ADDENDUM NUMBER 3
CONTRACT DOCUMENTS
FOR
SCOTT COUNTY REGIONAL SEWER DISTRICT
LEXINGTON, INDIANA STEP SANITARY SEWER AND ENGLISHTON PARK WWTP
CONSTRUCTION PROJECT

Date Issued: July 15, 2010

Issued By: Saegesser Engineering, Inc.

EXHIBIT 'A'

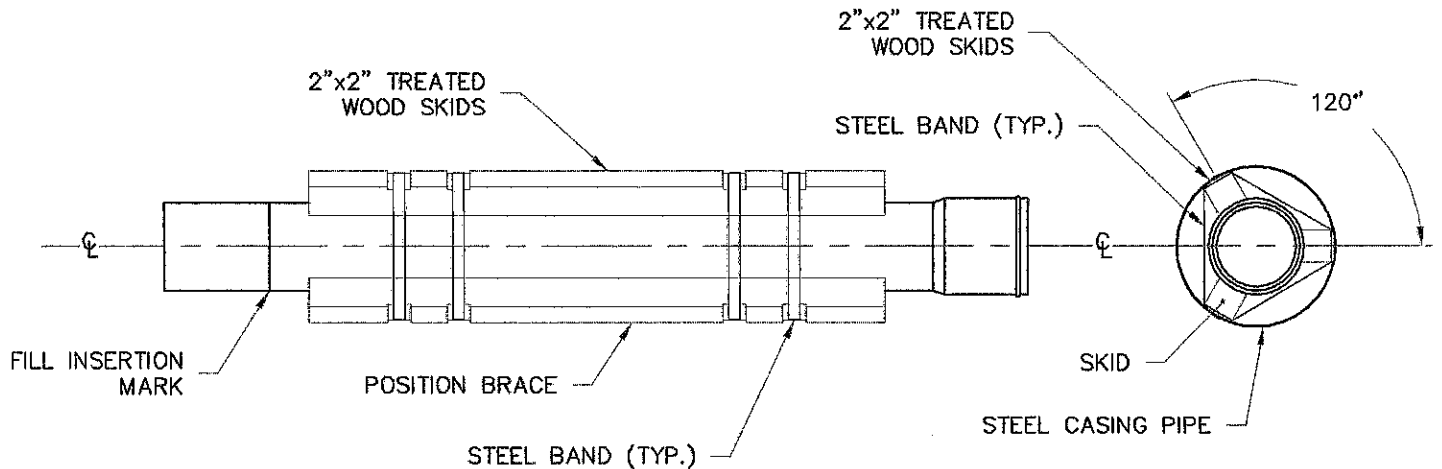
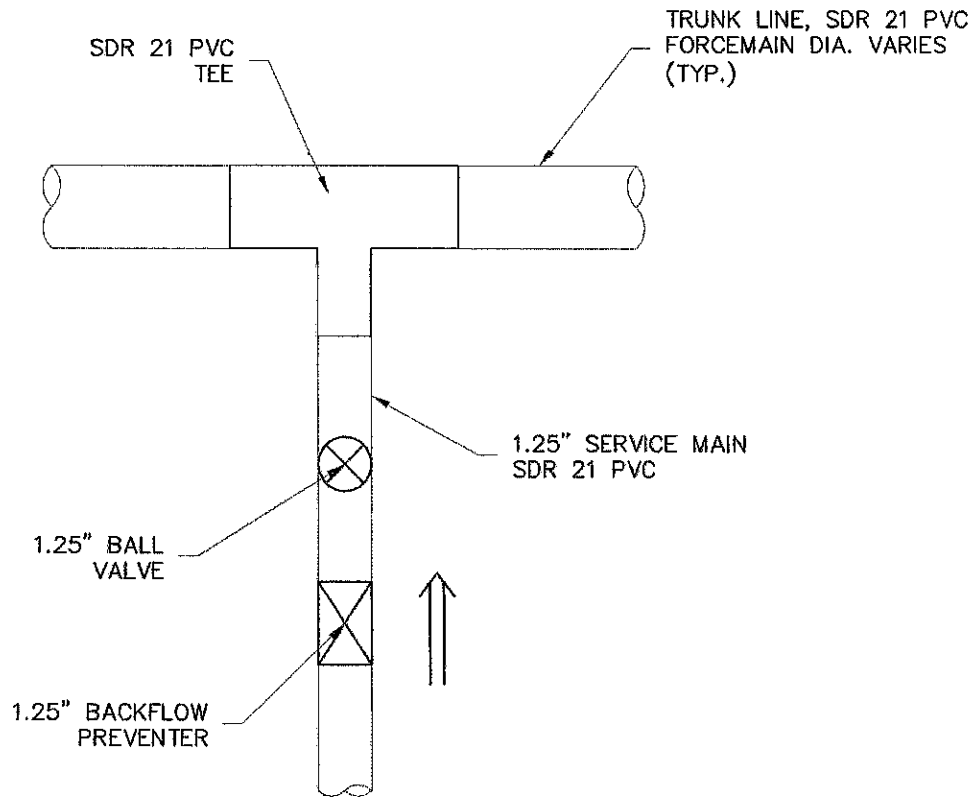
3. *Comment(s): Do bore under State Highways need steel casing? Response - [Yes, see attached drawing (Exhibit A) for additional details].*
4. *Comment(s): Will we need to use granular fill along Alignment D in State Right-of-Way (S.R. 203)? Response - [Yes, per InDOT specification.]*

13. Comment(s): Are we to put force mains at 36" cover or stay with your elevations per your profile sheets? **Response - [36" cover.]**
14. Comment(s): I count 5 - mainline crossings of force main across State Highways and 4 service line crossings. Are you going to pay these all under bid item #27? Do you have a detail on casing requirements? **Response - [There are 5 mainline crossings and 3 service line crossings across State Highways. These items will be paid under item #27 see attached revised Bid Schedule (Exhibit D). See attached Exhibit A for casing requirements.]**

29. **Comment(s):** Is lime dust an acceptable alternative to sand encasement? **Response - [No.]**
30. **Comment(s):** Bid item #27 Bore and Jack under Roadways. Typically a bore and jack is a bore with a steel casing pipe, is this your intent. On the plans it states to perform a directional bore (which I would interpret as no casing pipe required.) **Response - [All bored crossing under State Highways must be encased, so a bore and jack is required in those locations. See attached revised Bid Schedule, Exhibit D for clarification on bore and jack quantity. See attached Exhibit A for casing requirements.]**

EXHIBIT 'B'

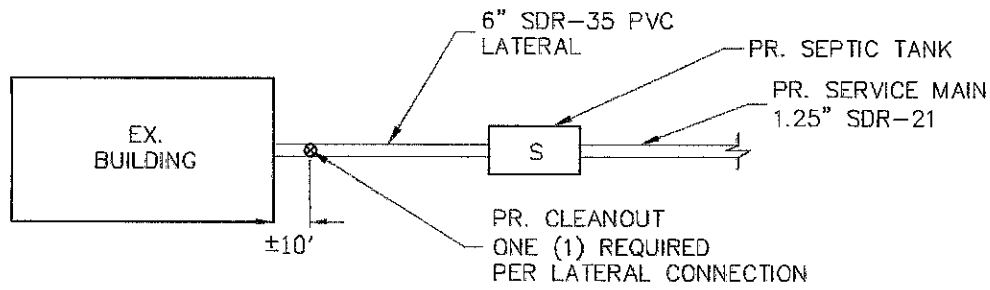
5. *Comment(s): Is a valve required at the 1.25" service connection to mainline force main? Response - [Yes, see attached drawing (Exhibit B) for additional details.]*

17. Comment(s): How will the connection be made between the service lateral and the trunk line? Will this be a "T" in the line or will it be fused connection and tapped or saddle? **Response - [See attached drawing, Exhibit B.]**

18. Comment(s): Will we need a valve and a backflow preventer at the truck line, where the lateral connects? **Response - [See attached drawing, Exhibit B.]**

EXHIBIT 'C'

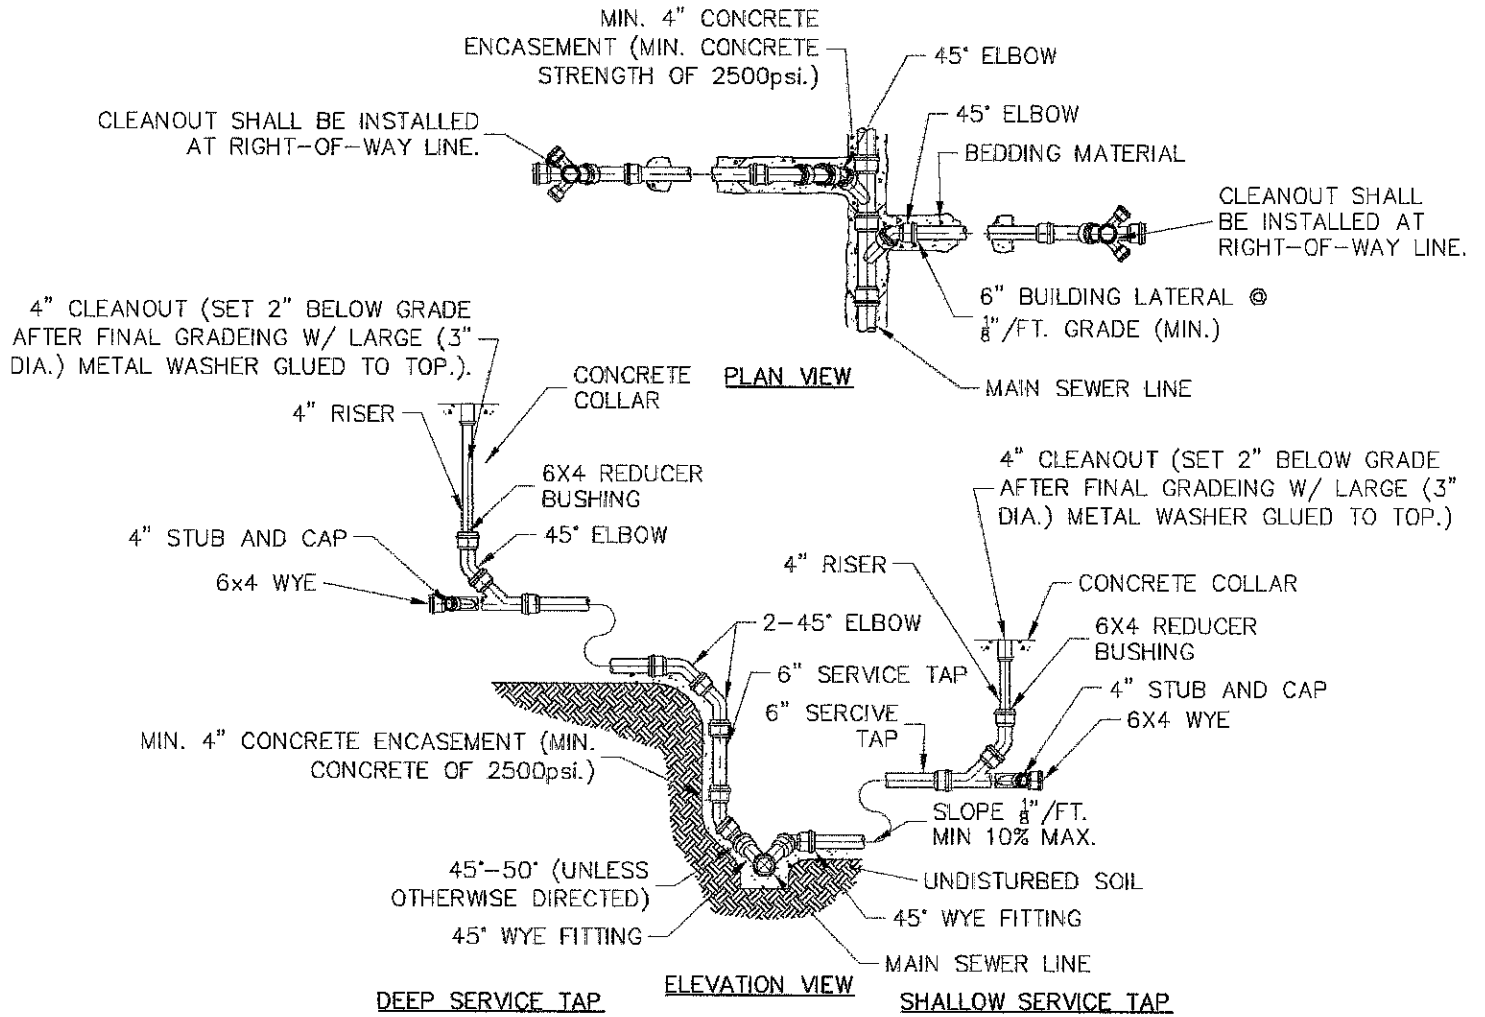
6. *Comment(s): Are we to install cleanouts between house and new tank for each connection? Response - [Yes, see attached drawing (Exhibit C) for additional details.]*

34. **Comment(s):** Bid item #6 says 6" sdr 35 pipe w/cleanout. Can you provide a detail for the clean outs? Also how often are cleanouts required? **Response - [Yes, see attached drawing, Exhibit C. One (1) cleanout is required for each lateral.]**

EXHIBIT 'E'

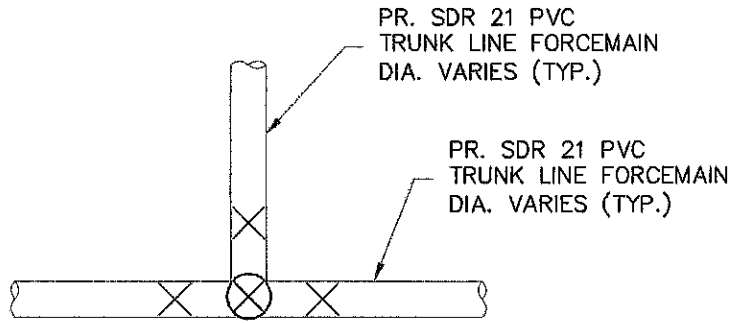
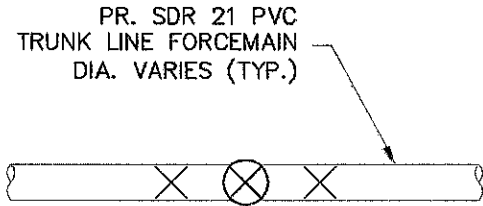
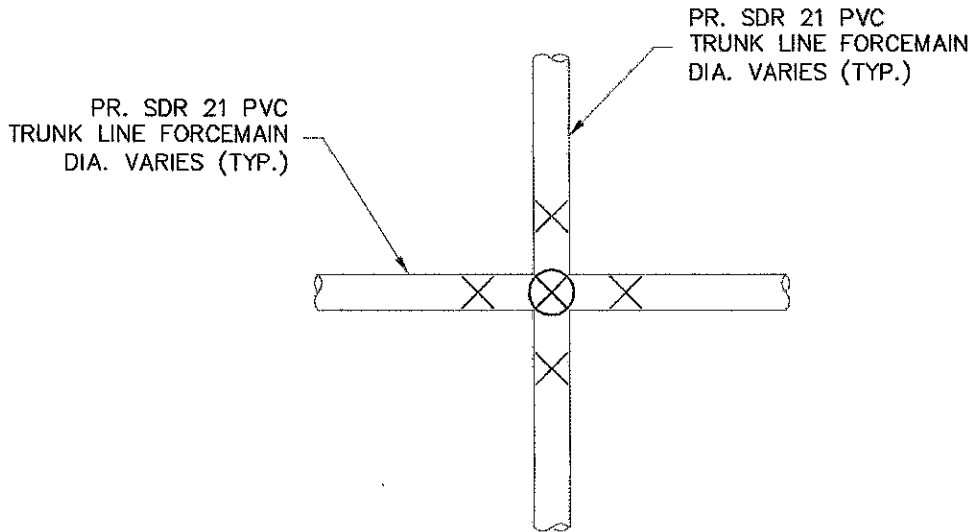
27. Comment(s): In regards to bid item #9 flushing assemblies. In locations where there are intersecting lines it shows 3 flushing assemblies and the detail on p.33 shows there being 3 valves and one flushing assembly. Will this be paid as 3 flushing assemblies or one? If it is paid as one flushing assembly the bid quantity will need to be reduced. As of now I

can only find 44 of the 50 flushing assemblies. **Response - [Assemblies will be paid per unit, which includes all valves, piping, boxes, etc. See attached detail drawing, Exhibit E to clarify assembly placement. See attached revised Bid Schedule, Exhibit D for quantity corrections.]**

Drawn By: MRS	File Name: 0203.dwg
Checked By: WAS	Connection Site Plan (7-13-10)
Drawing Scale: 1"=40'	Date: 7/13/10
	Sheet No.:

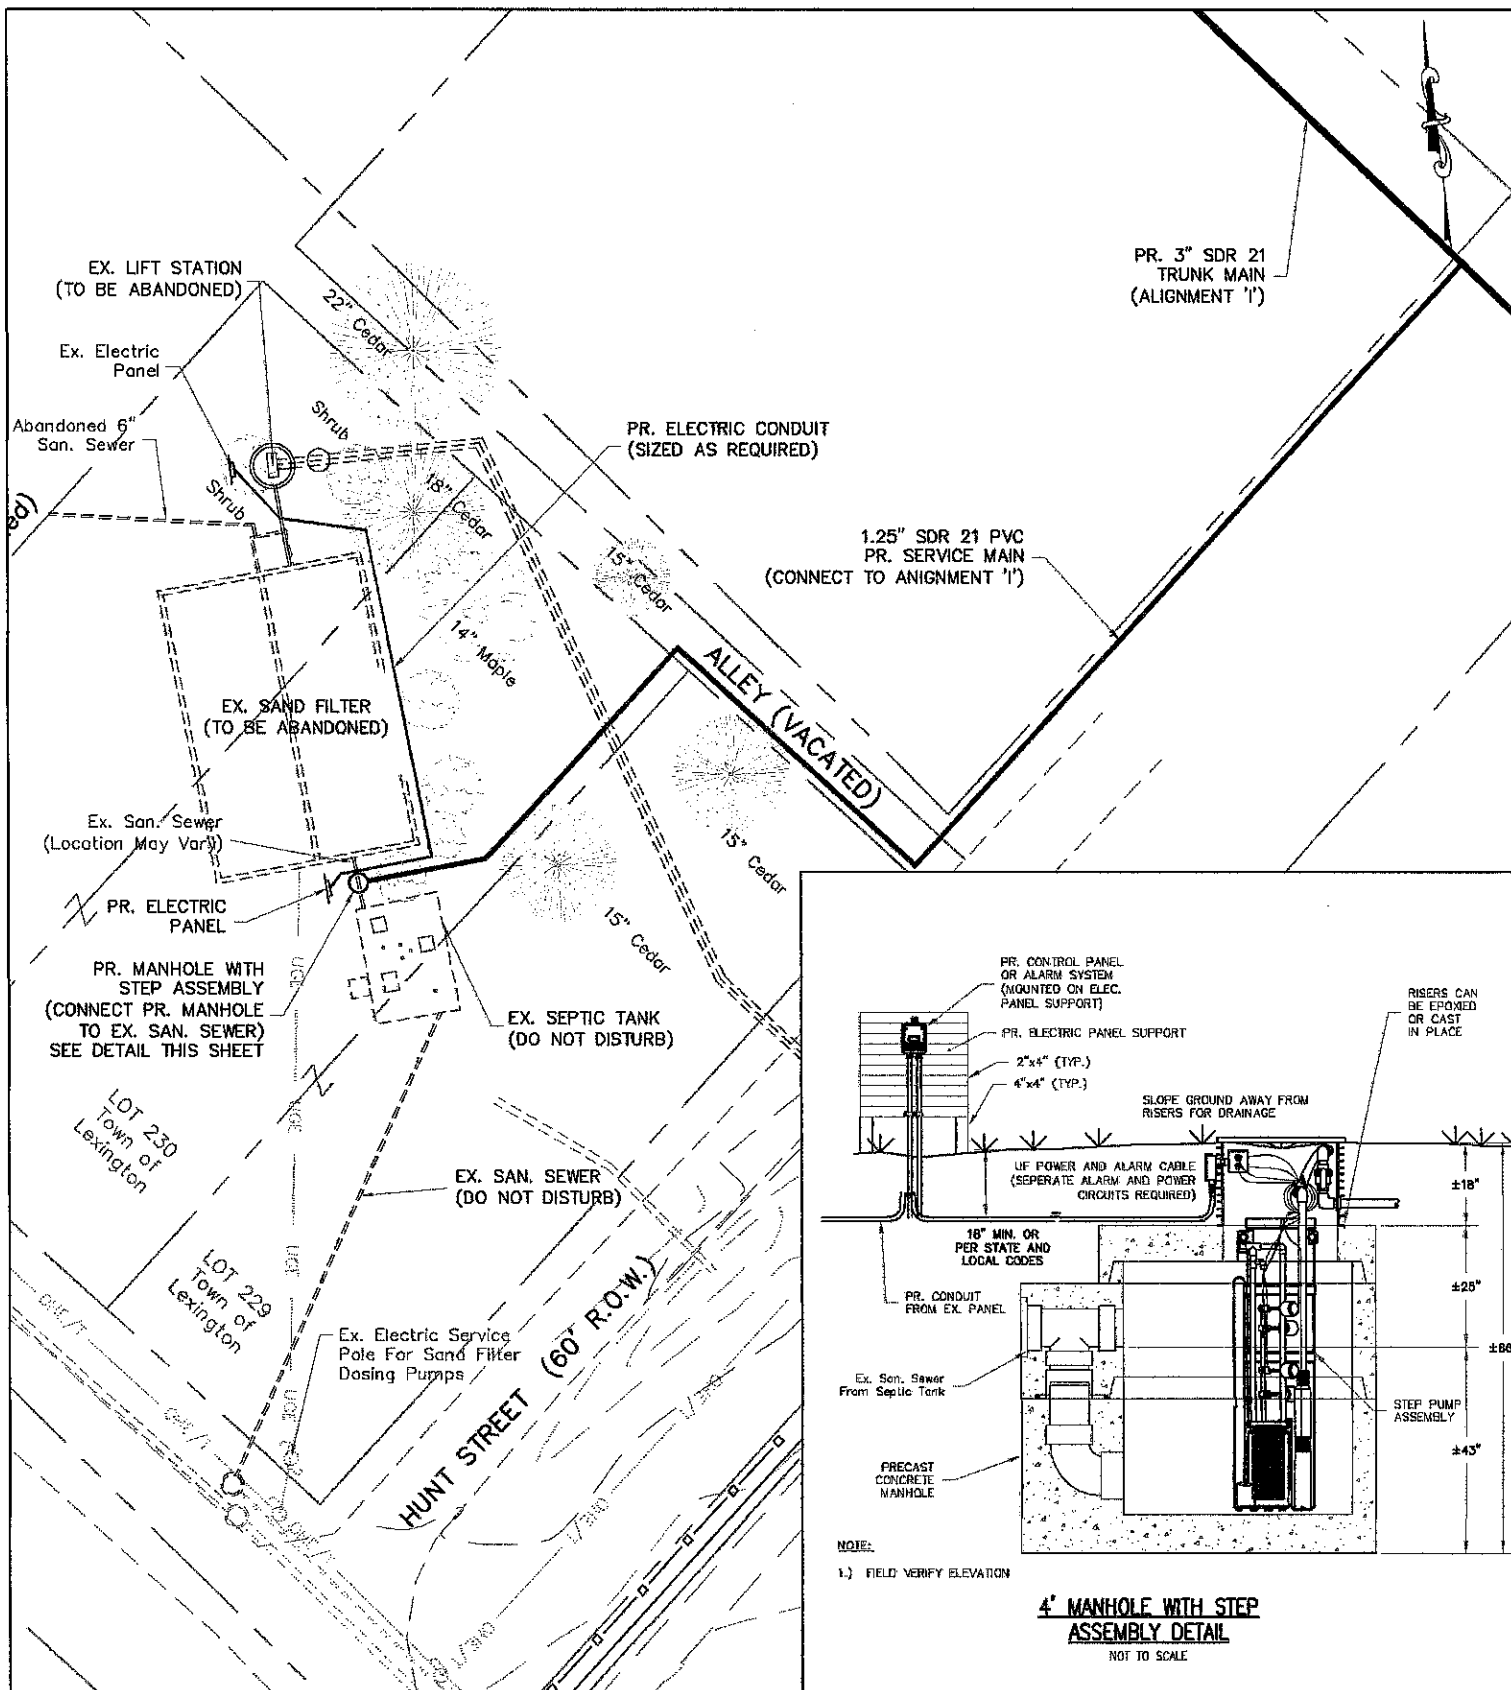
28. **Comment(s):** Sheet 8 of 35 if the existing septic tank gets abandoned, will there need to be a new one put in? **Response - [See attached detail drawing, Exhibit F.]**
